IVANHOE ESTATE CONSERVATION CORRIDORS PLANNING PROPOSAL

City of Ryde Local Planning Panel Report

Attachment 4 – City of Ryde Submission for Ivanhoe Estate Redevelopment Stage 3 (SSD-30530150)

Figure 1 – Concept Development footprint and impact on STIF

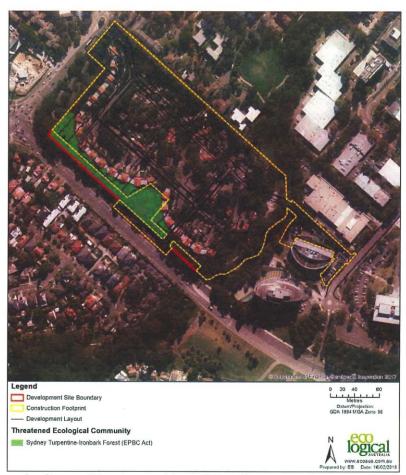
OEH suggests the development footprint could be reduced and higher building heights could be proposed to preserve more STIF. It is noted that a 65m height control (equivalent to 21 storeys based on 3m floor to ceiling heights) is proposed along the southern boundary to Epping Road, refer to Figure 2 below. The consultant's report does not assess what the impact is on the vegetation remaining from overshadowing and limited light especially vegetation along Epping Road where a 65m height is proposed and where good quality STIF is located. The proponent should calculate the reduction in the conservation value of the remaining patch of vegetation not just the areas that are removed.

Figure 4 Existing Zones

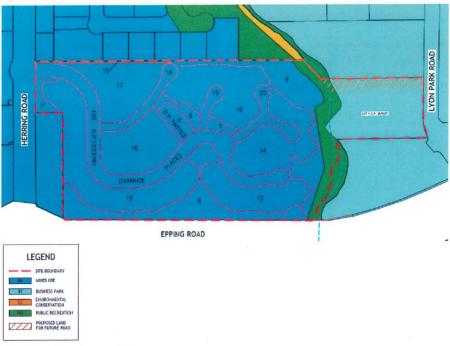
- It is recommended that the existing adjoining E2 zone be extended into the site within the riparian
 corridor as shown in Figure 4 below to protect both the adjoining corridor and the rehabilitated
 corridor in the long-term as this zone will ensure stronger protection.

Figure 4 Existing Zones

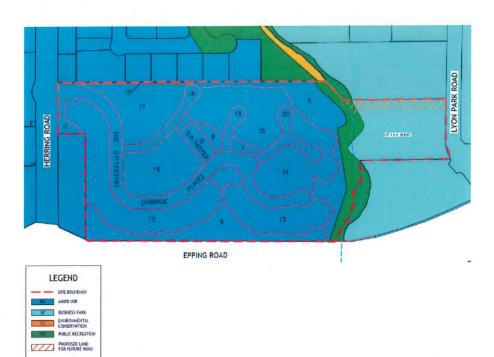
- It is recommended that the existing adjoining E2 zone be extended into the site within the riparian corridor as shown in Figure 4 below to protect both the adjoining corridor and the rehabilitated corridor in the long-term as this zone will ensure stronger protection.

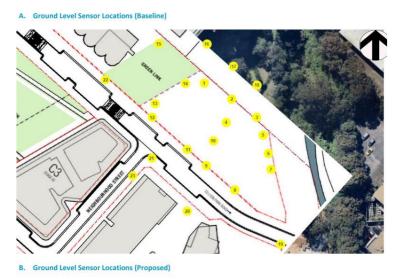
- As per the submitted Wind Impact assessment (Appendix U Wind Impact Assessment) revision to the plans is required to provide a 1.8m high fencing around the communal open space. Currently the plans submitted show a 1.5m screen. Refer below figure
 - It is recommended to ensure a 1.8m vertical windbreak (e.g. impermeable screen or dense planting or combination) surrounds the accessible rooftop.

In addition, it is unclear if the Wind Impact assessment has considered the wind impact to the proposed recreation area at Shrimpton creek and skate park. In review of the assessment, it appears to not have contemplated wind impact at the skate park, and has suggested it is not considered due to setbacks. See below quote from Wind Impact Assessment:

Council requests that the wind impact assessment be revised to consider such impacts.

Enhanced version of GFA Schedule showing level 14 – communal open space not included in FSR.

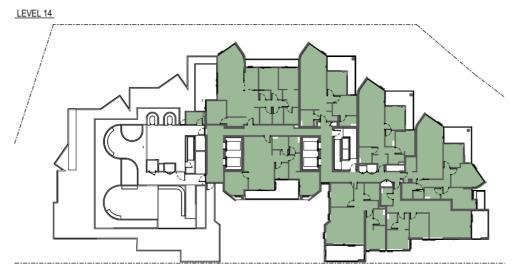
As per the above, even at 1.5m high the wind shielding is to be counted as FSR. The Applicant's FSR schedule has not counted the 1.5m shielding as FSR. The applicant needs to recalculate their FSR schedule. See below extract.
